Sams Attire Ltd

Bhuiyan Tower, Plot No. 10, Jamgora, Ashulia Road, Savar, Dhaka
(23.93670N, 90.28447E)

11 March 2014

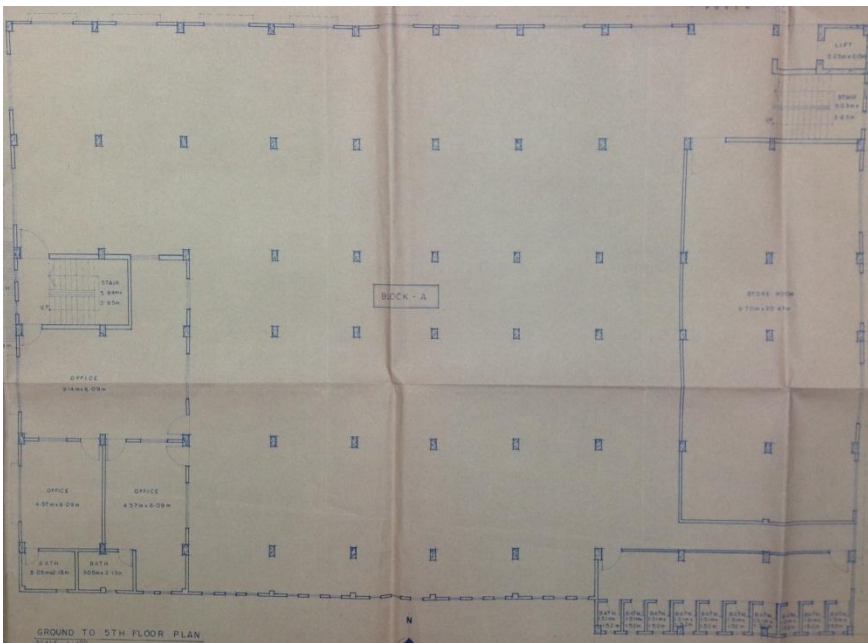
**Columns appear to be stressed in excess of
normal design limits**

Cursory calculations indicate column working stress is in excess of normal design limits.

Building Engineer is to perform detailed calculations including a Detail Engineering Assessment (See attached scope) and concrete tests to prove column size and (if required):

- Reduce loads by vacating floors
- Reinforce columns

Roof Plan

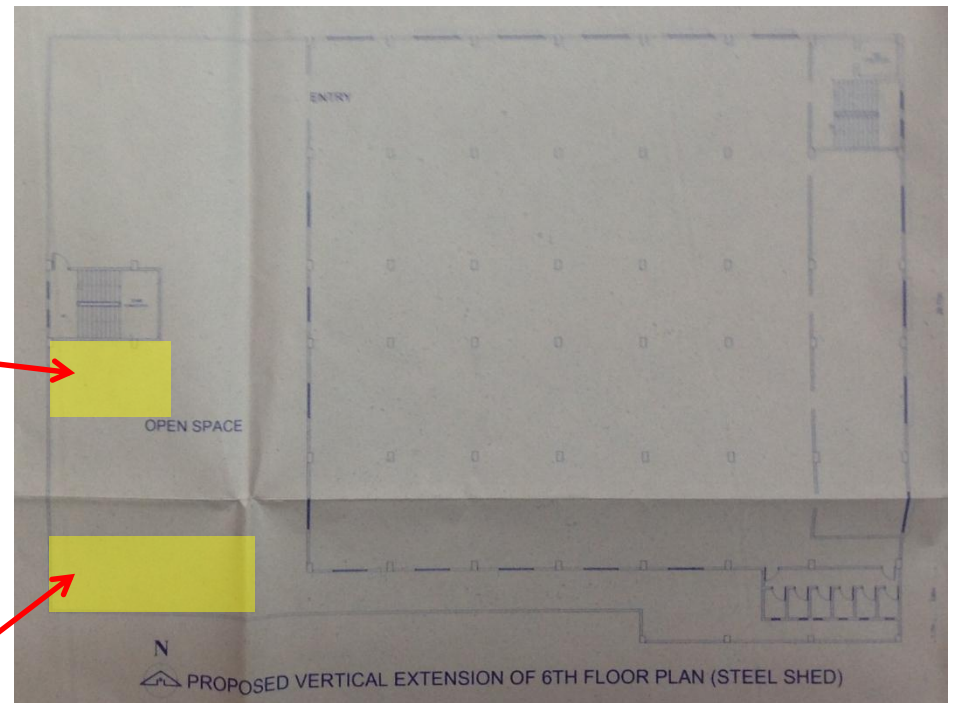
Structural adequacy of concrete roof slab and columns to support antenna house and water tanks

High Loading on Roof

Building Engineer to check that concrete roof slab and columns have been designed to accommodate loads from Antenna house and water tanks.

Floor Plan – Export Carton Area/Accessories Store

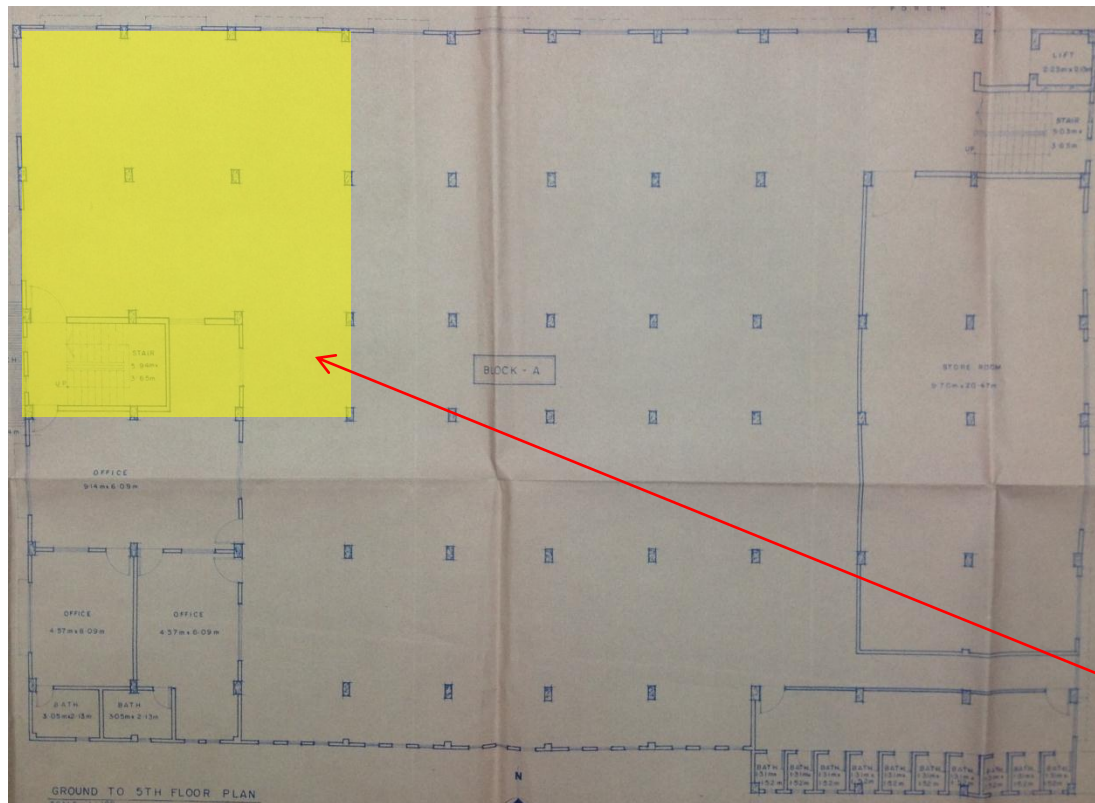
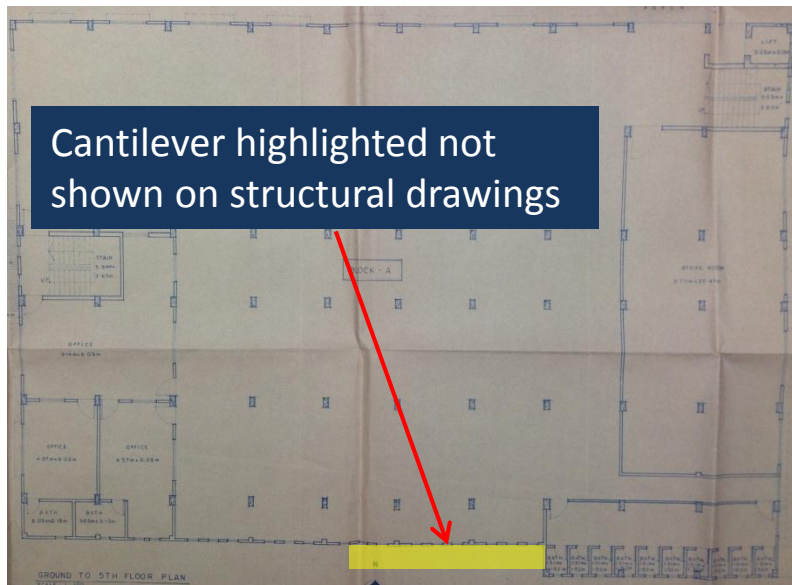
Management of storage loads

Management of Storage Loads

Building Engineer to prepare controlled loading plans for all floors which will designate where storage can be placed and to what height.

Roof structure to Dining Area

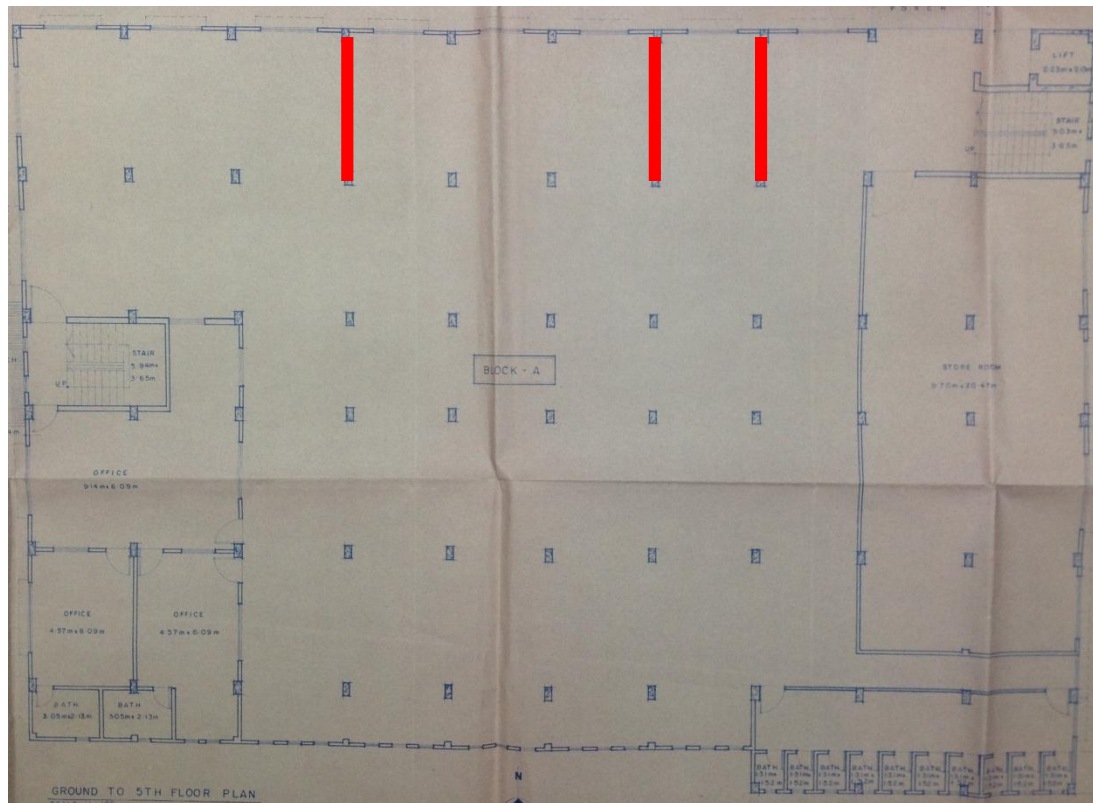
**Check required to confirm that the steel roof
rafters over the dining area are adequately
designed to allow for notch in the steelwork for
the roof gutter**

Dining area structure not shown on structural drawings.

Building Engineer to check design of steel rafter allowing for notch in the steelwork for the roof gutter.
